**Request for Further Information - Engineering Response
(South Dublin County Council Register Reference
SDZ22A/0006)**

Phase 2 Proposed Development at Tandy's Lane Village,
Adamstown, Co. Dublin

August 2022

Waterman Moylan Consulting Engineers Limited

Figure 1: Masterplan – Route Overview

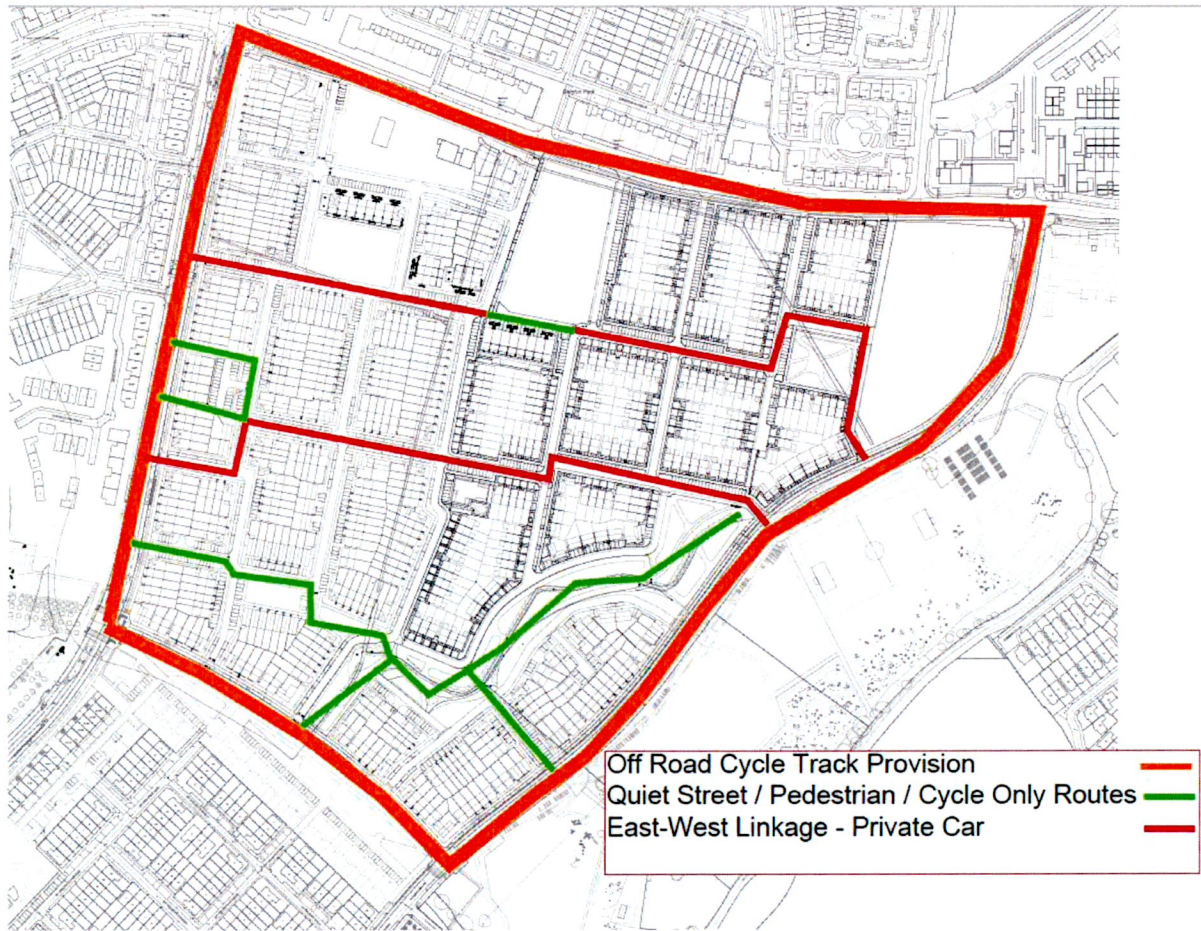
The east-west link roads should be better provided for in the proposed development. While the northern east-west link is somewhat restricted by the permitted Phase 1, this should be facilitated in the subject site if provided for under Phase 3. The southern east-west link should be revised to provide better connectivity, in particular for pedestrians and cyclists.

The proposed site layout has been updated in order to improve east-west link provision, and in particular in respect of pedestrian and cycle connectivity. Whilst off-road cycle facilities are provided on the boulevard to the west, Tandy's Lane to the south, Adamstown Park to the East, and Adamstown Drive to the north, it is proposed that internal routes within the overall tile will be on road, in order to promote appropriate driver behaviour within the tile where lower operational speeds are desired and lower traffic volumes expected.

Whilst the SDZ scheme seeks to maximise east-west linkages, it is proposed that these be wholly provided for pedestrians and cyclists in a direct manner, and where possible along low car usage or car-free routes as per the Masterplan Route Overview seen in Figure 1 below to encourage the use of sustainable modes, whilst maintaining east-west links for private car use.

The provision of the northern east west link through the village centre site had been considered as part of the review, but it could not be accommodated as it was not feasible to provide a suitable connection. The layout as permitted under the Phase 1 scheme constrained the Phase 2 site with no roads or service connections allowed for. Furthermore, the provision of a through vehicular route through the village centre site would steralise a significant portion of the village centre site and make the site unviable, and restrict the ability to provide a SDZ compliant layout in the village area. In addition, the northern east-west link has been straightened in an effort to improve the desire line from the Boulevard to the future village centre and Phase 1. Furthermore, a pedestrian link at the southern east-west link to improve desired lines and permeability for pedestrians has been provided, but it was not feasible to amend the layout of that road as this area is constrained by existing service and access points which are built within the Boulevard and Phase 1 areas.

The existing and proposed linkages through the Phase 1 and Phase 2 areas are indicated on the plan extract below which facilitate car movements but prioritise pedestrian and cycle movements.

WATER BUTT - ELEVATION -
Scale 1:20

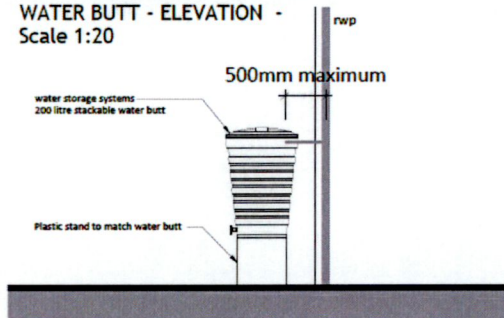
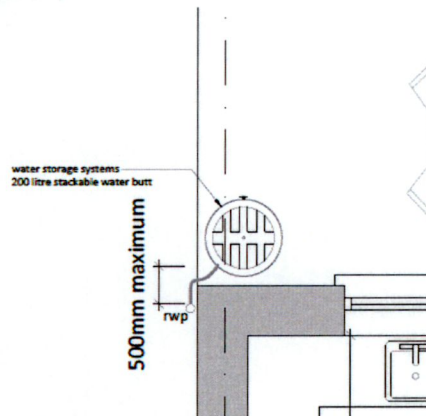
The applicant is requested to submit revised landscaping and engineering proposals incorporating Sustainable Urban Drainage System (SUDS) measures including swales, permeable paving, tree pits, water butts etc., ensuring consistency with engineers drawings/proposals.

A water butt is a structure or barrel with the purpose of collecting surface water runoff from a unit's roof through the downpipes on the perimeter walls. It is proposed that a water butt be installed at each unit to collect the surface water runoff from the roofs as per the Quintain typical detail below.
